From: [BOS Legislation.. \(BOS\)](#)
To: [Lew, Lisa \(BOS\)](#)
Subject: FW: Expert Reports For Golden Gate Valley Library Hearing
Date: Thursday, April 15, 2021 3:37:41 PM
Attachments: [Brief Expert Bios.docx](#)
[Corbett expert report GGVL.pdf](#)
[4.10.21 Letter Golden Gate Branch Library.pdf](#)
[Verve light study findings.pdf](#)
[Edward Dean Response GGV Library.pdf](#)

All five experts reviewed the Planning Department's two studies (1) Daylight Impact Analysis Report (December 2020) - an assessment of the project's impacts on the Library's interior light; and, (2) Shading Impact Analysis Report (December 2019) - impact of shading on the Library's photovoltaic system.

RE: San Francisco Planning Department's Second CEQA Exemption for 2651-2653 Octavia Street (Case No. 2018-011022 PRJ) Regarding the Impact of the Proposed Project on the Golden Gate Valley Branch Library, A Historic Resource

Figure 4.5. Ideal vertical footcandle distribution at bookstacks. Light fixtures should be selected and laid out to minimize electric power requirement while maintaining this light distribution.

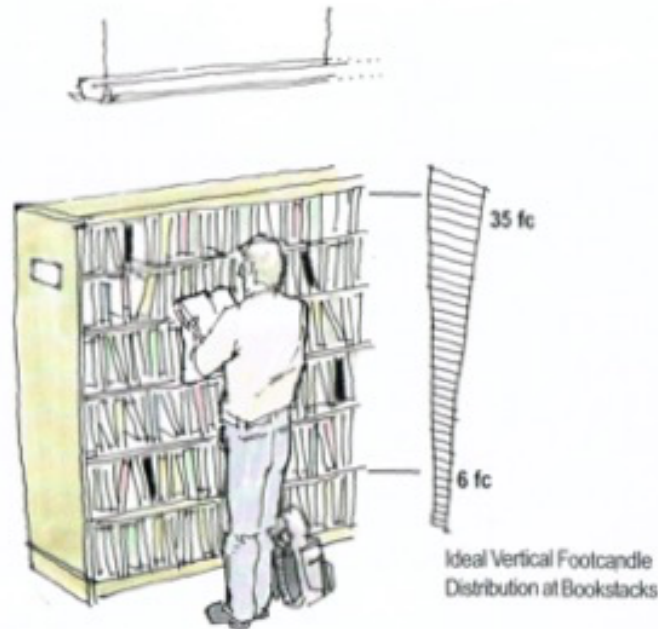
Most people do not understand that the lighting level recommended for the stacks is in vertical footcandles (or vertical lux) and these vary depending on the level of the shelf. (See diagram and explanation below.) The stack area lighting is NOT horizontal illumination as in the reading areas. One needs adequate light to read the titles on the books. So the blanket average can't really be applied to stack areas.

Book stacks must be lit adequately so that patrons can find books and staff can shelve books without visual discomfort. Evenness of illumination across the stack face is more important than achieving a high lighting level at any single point. The lighting level should be a minimum of 6 fc (footcandles) measured vertically on the face of the book spine at a height of 12 inches above the floor, and a maximum of 35 fc at any height, so that no more than a 6:1 ratio results across the entire vertical face of the bookstack.
